Section 6 comments from Ballot on Draft Standard D2 (Vic Hayes, Chair, AT&T WCND)

Figure 6-10: RTS/CTS with Fragmented MSDU

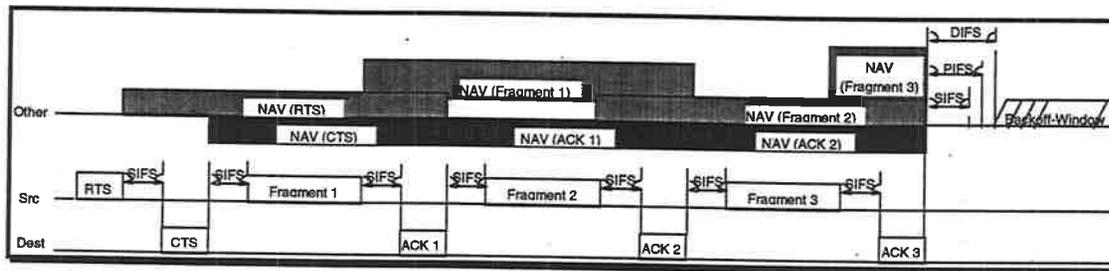
6.2.6.6	BTh	E		add box around RTS in Src line of Figure 6-10	All other frames have a box.	
	6.2.6.6	ws	e		"warrents"	spelling	
	6.2.6.6	DW	E		Figure 6-10 should be updated to correctly show the NAV as is caused by the Duration field in the data frame (from the end of the last fragment till the end of the Ack following the next fragment.

6.2.6.6	RJa	T	N	Figure 6-10 is incorrect. NAV (Fragment 1) should begin at the end of fragment 1 and continue until end of ack 2. NAV (Fragment 2) should begin at end of fragment 2 and continue till end of ack 3. NAV (Fragment 3) should begin at the end of fragment 3 and continue until the end of ack 3.	I believe that this was accepted at an eariler meeting.
